CITY OF TAMARAC

NOTICE OF WORKSHOP MEETING

1. **TR13275 - Marker Agreement for Colony West**

RE: **Temp Reso # 13275 – Change Order with Marker Group in the amount of $1,041,903 to $9,235,757**

SHEET NO.:
ID-302

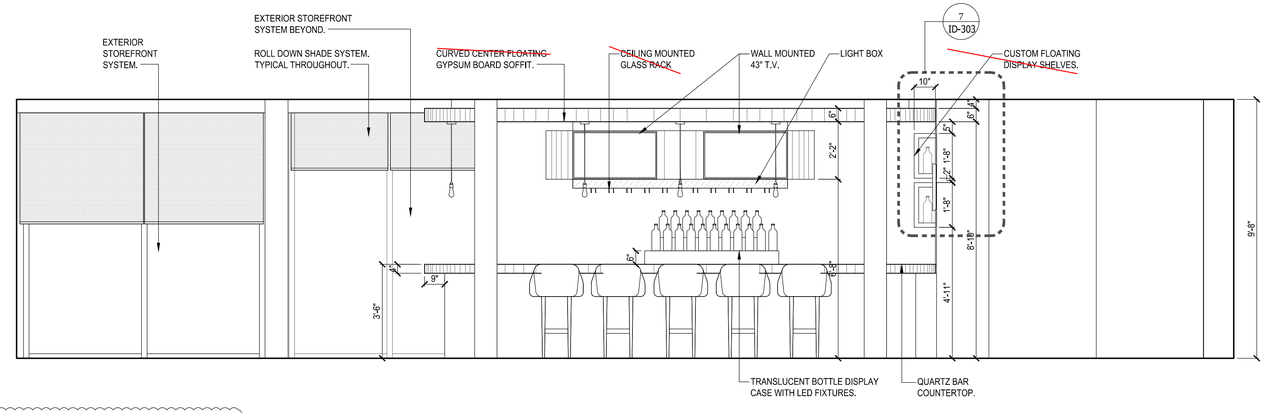
All wood paneling eliminated

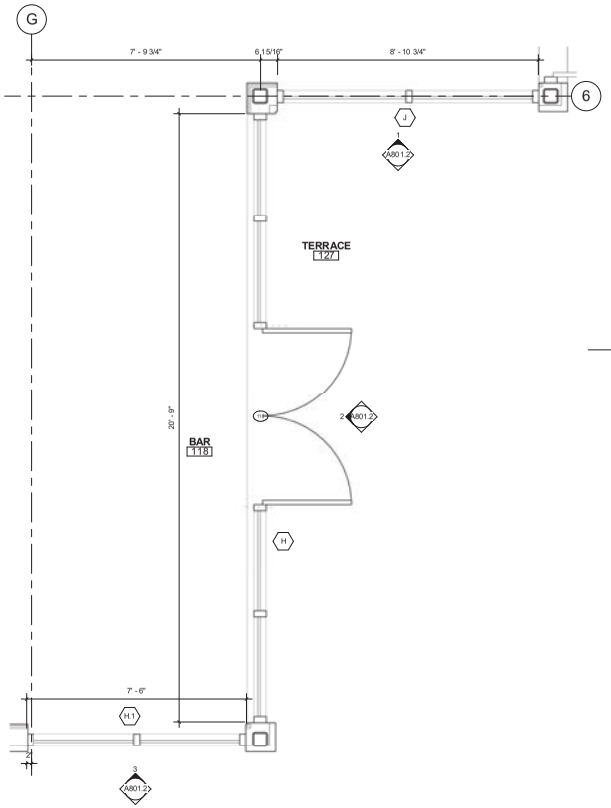
All transoms eliminated

See comments on A/801
